January 24, 1992  
LD-92-006

Docket No. 52-002

Subject: Response to NRC Requests for Additional Information

RESPONSE TO NRC REQUESTS FOR ADDITIONAL INFORMATION  
PLANT SYSTEMS BRANCH

Figure  
9.5.4-1

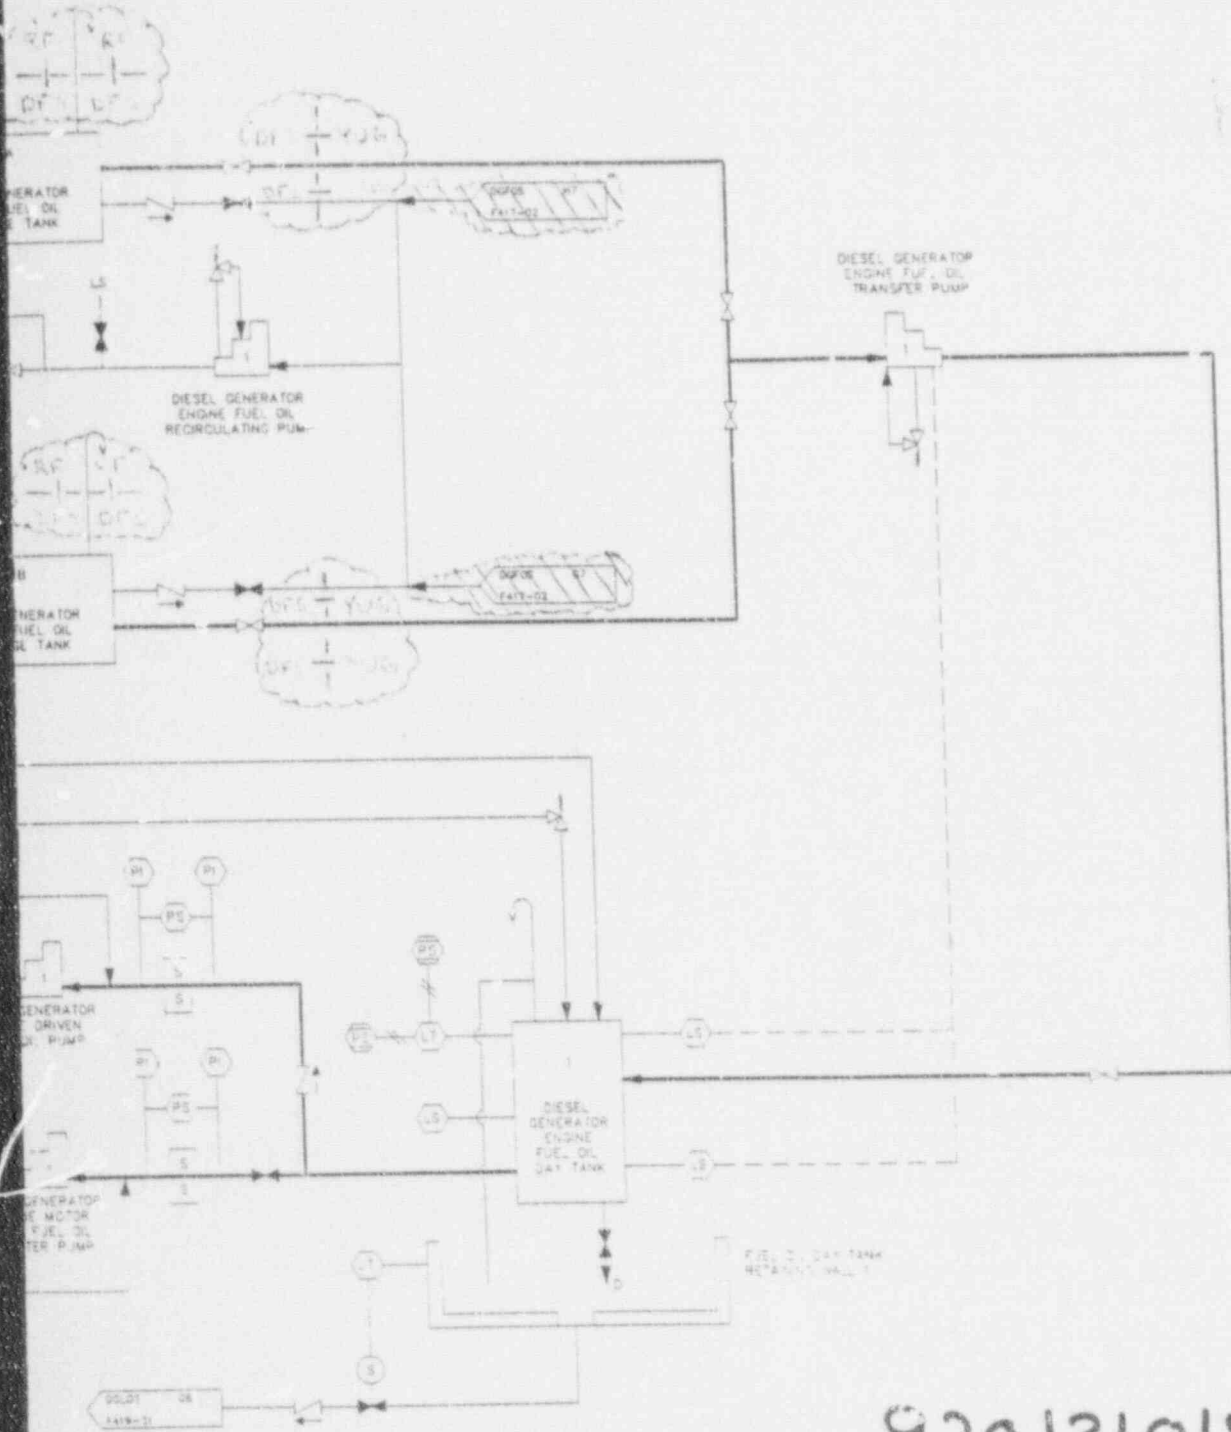
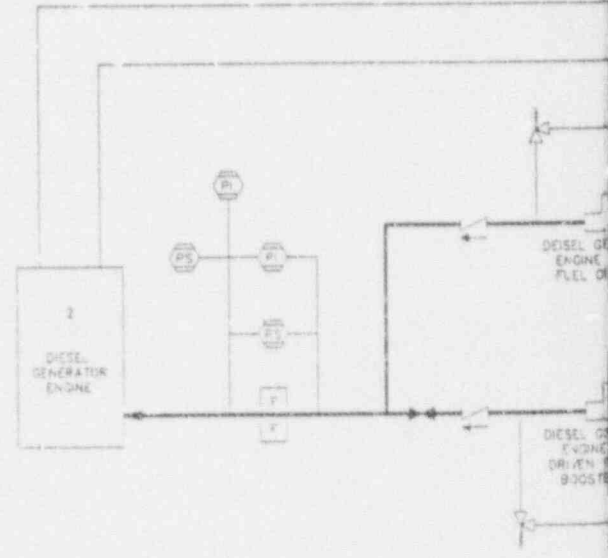
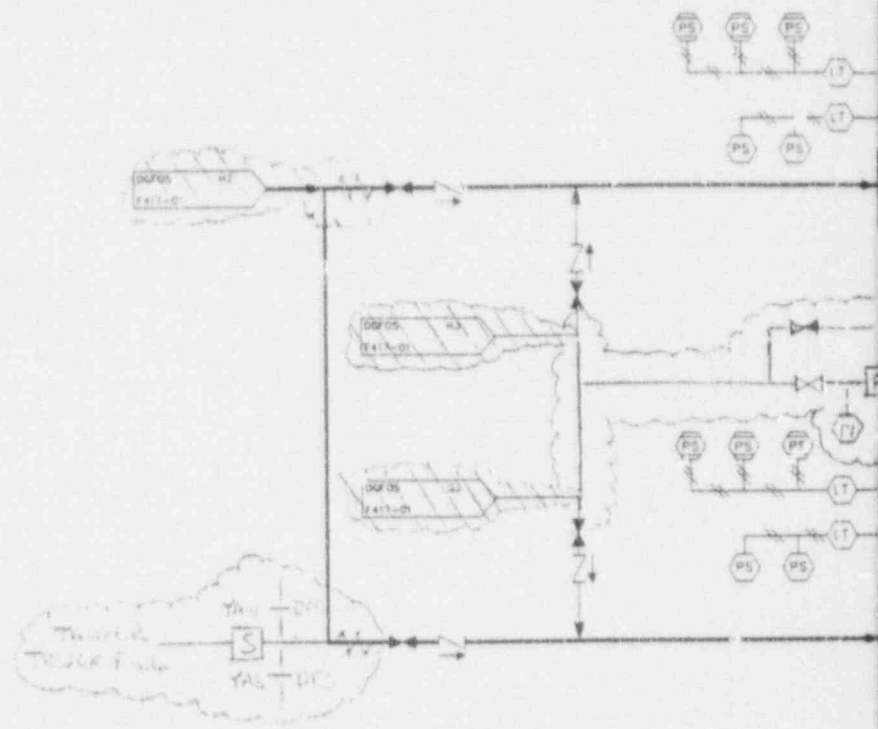
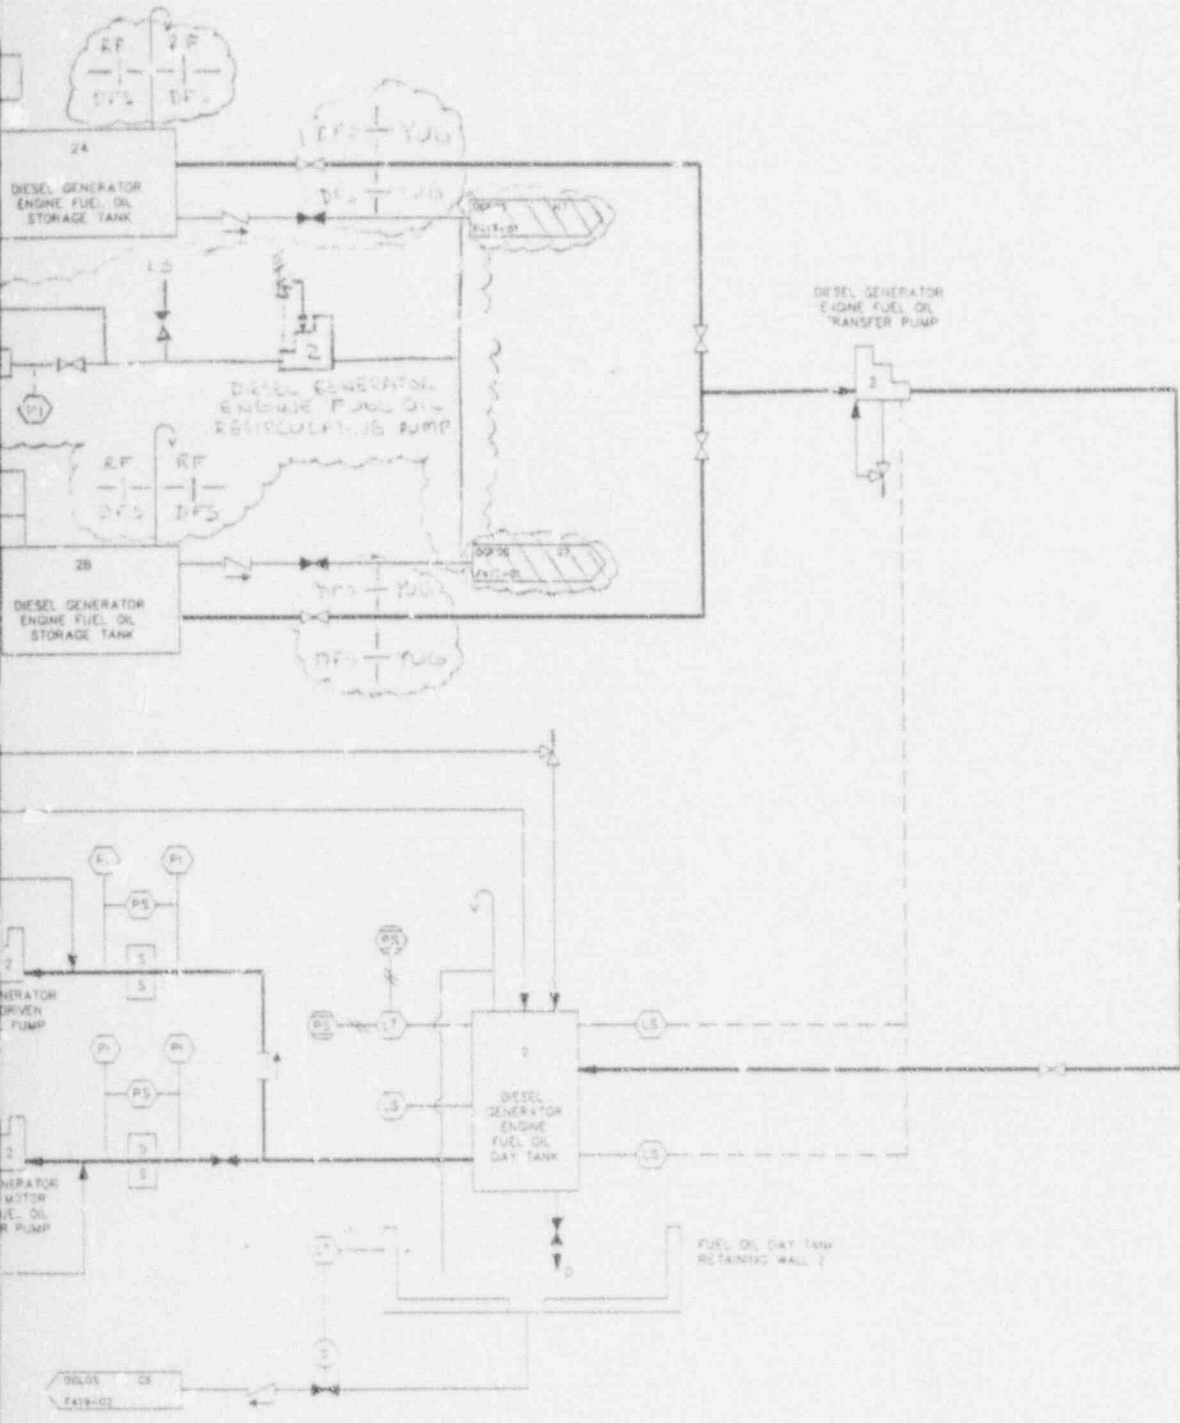
- e. Figure 9.5.4-1 shows provisions for drains in the fuel oil day tank but the text does not discuss the means to control water accumulation in the day tank. Provide a discussion of the control of water in the fuel oil day tank that addresses the recommendations of NUREG/CR-0660.

Section 9.5.4.1, Section 9.5.4.2.1, and sheets 1 and 2 of Figure 9.5.4.1 of CESSAP-DC will be revised to reflect the separation and location of redundant fuel oil storage components. A marked up copy of these revisions is attached.

DELETE CROSS-HATCHED AREAS

ADD ITEMS IN CLOUDS
